TOWN OF NEWBURGH PLANNING BOARD TECHNICAL REVIEW COMMENTS

PROJECT: FARRELL INDUSTRIAL PARK

PROJECT NO.: 20-16

RE: JMC Project 18156 Farrell Industrial Park Route 300 Town of Newburgh, NY

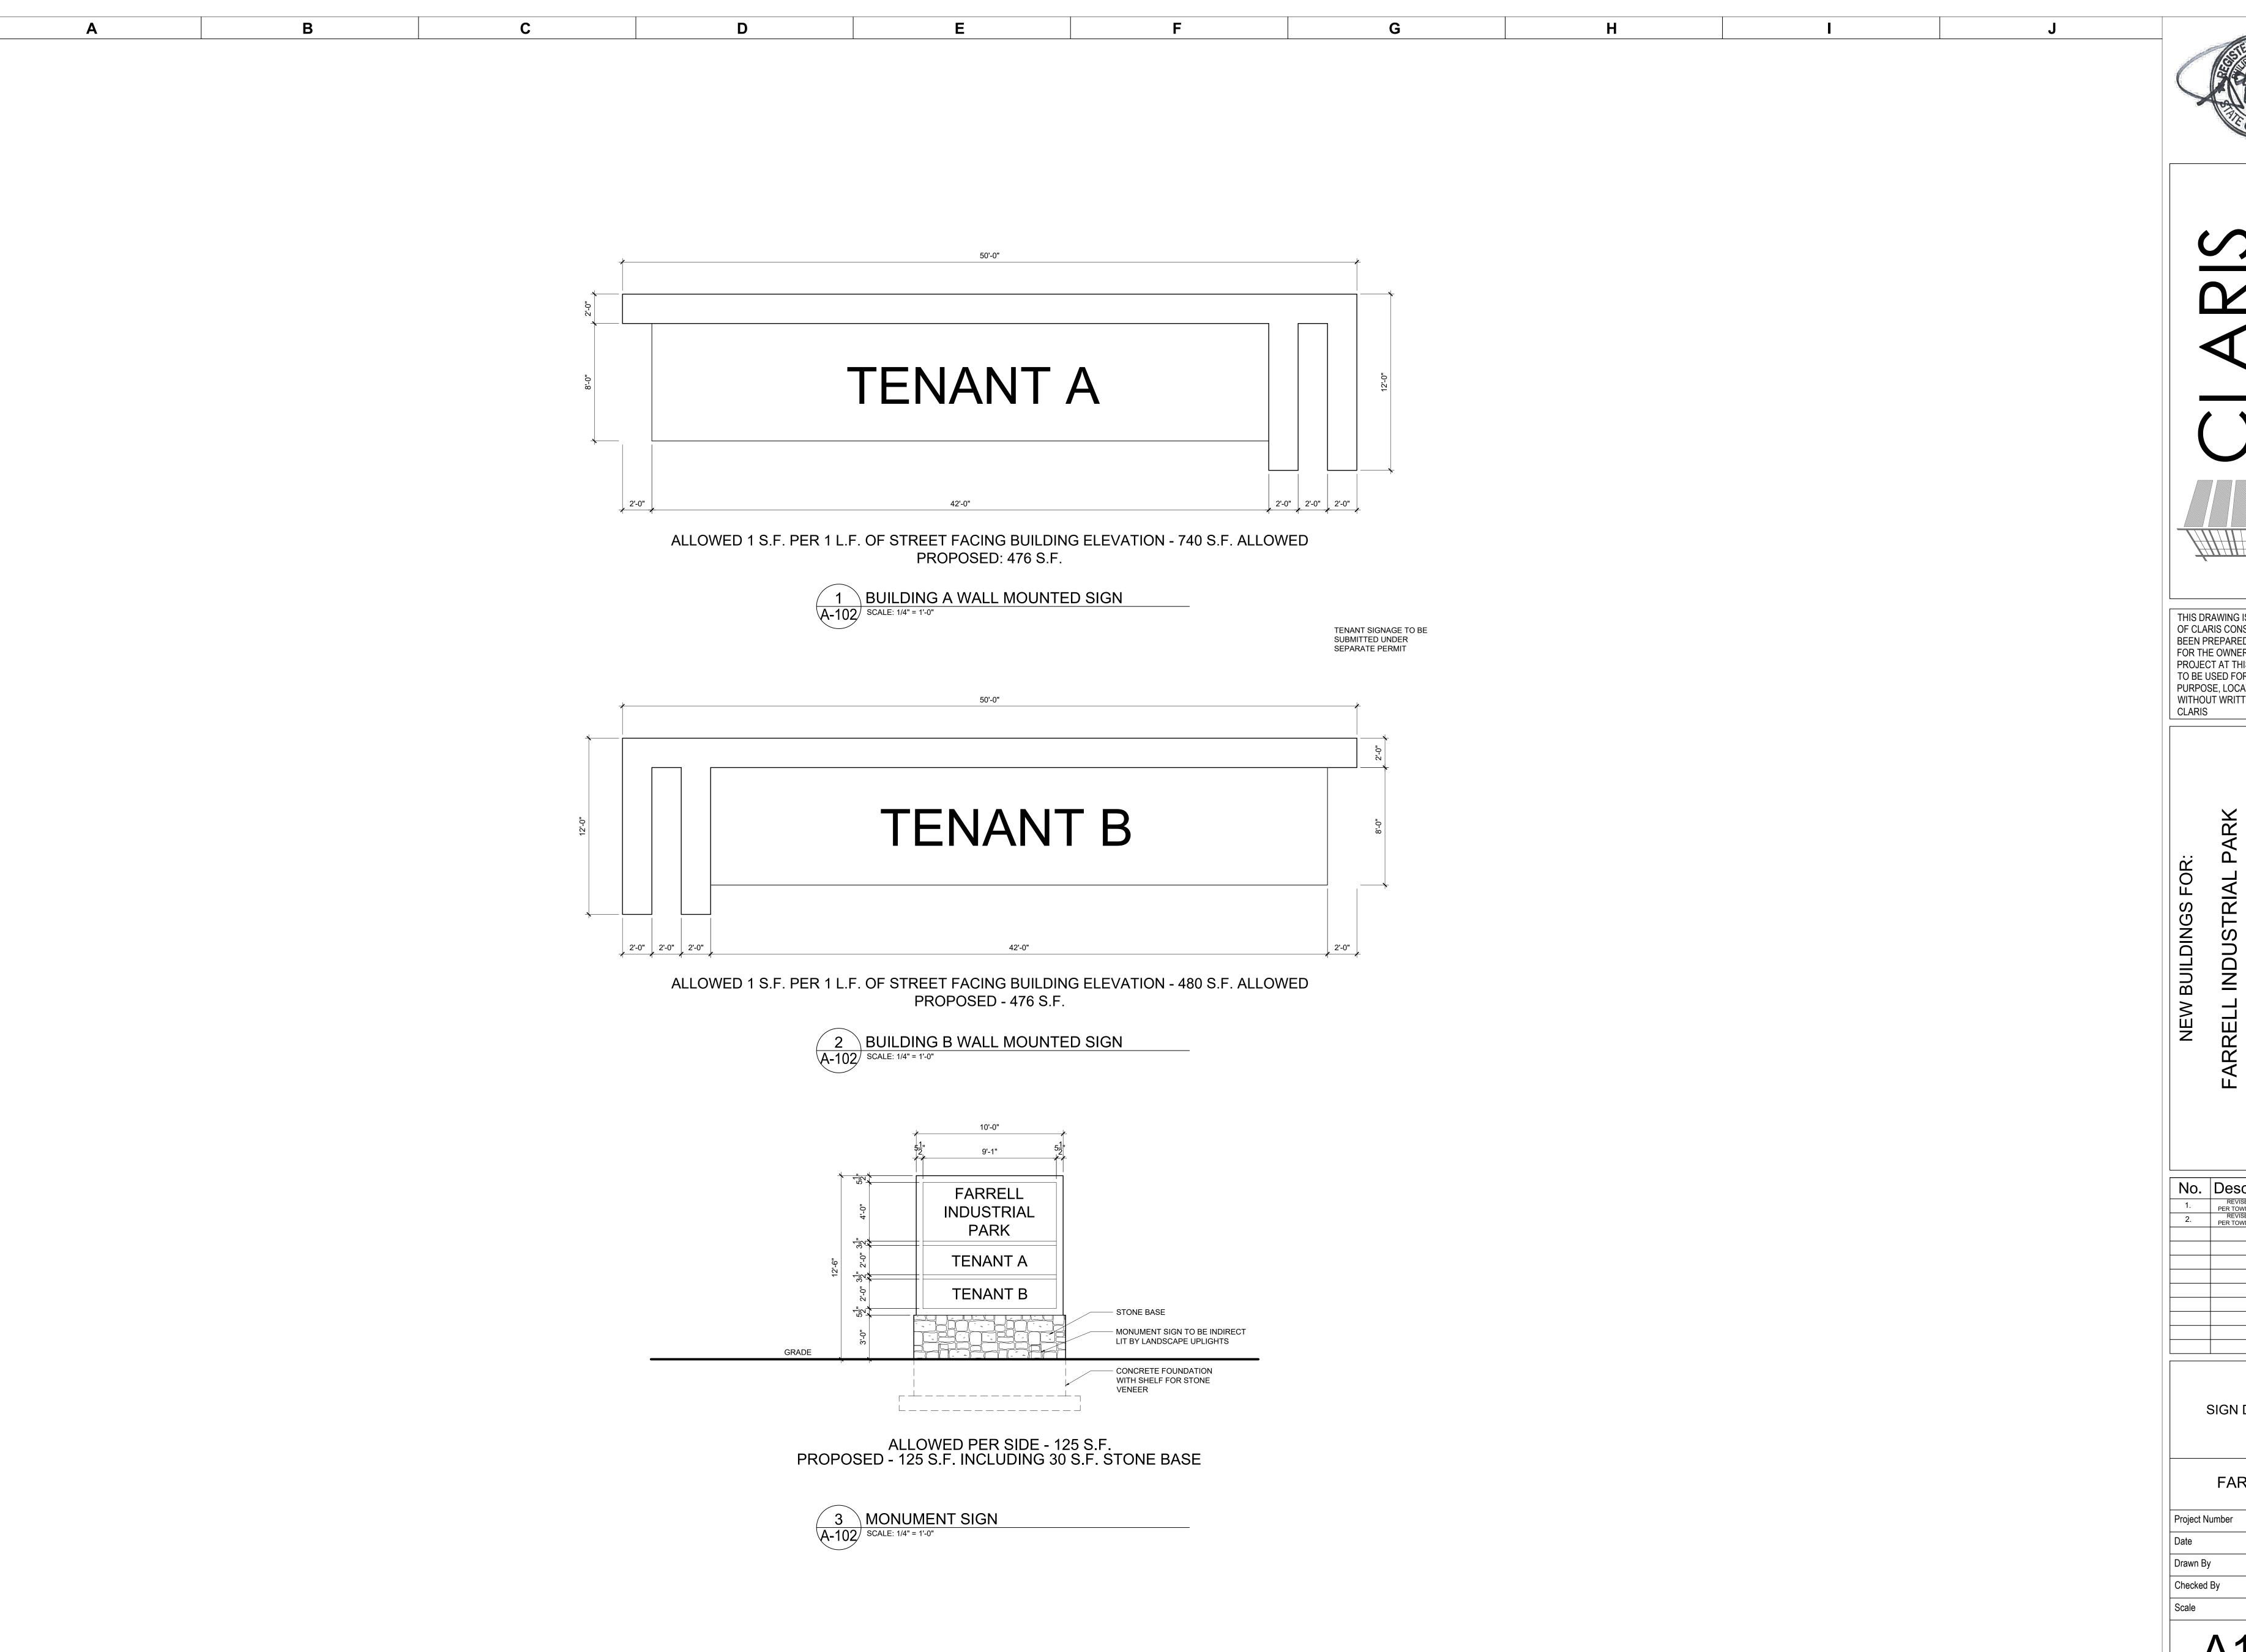
Include in the notes that all replacement plants shall be of the same size and species as specified on the planting list.

Amend the notes to include that the Landscape Architect's inspection will be performed the two following growing seasons as well as after initial planting, per the two year plant survival warrantee.

Note 12 on Drawing L-100 has been revised to include references for replacement of the plant material at the size and species indicated on the plant list.

Note 12 on Drawing L-100 has been revised to reference the above noted inspections.
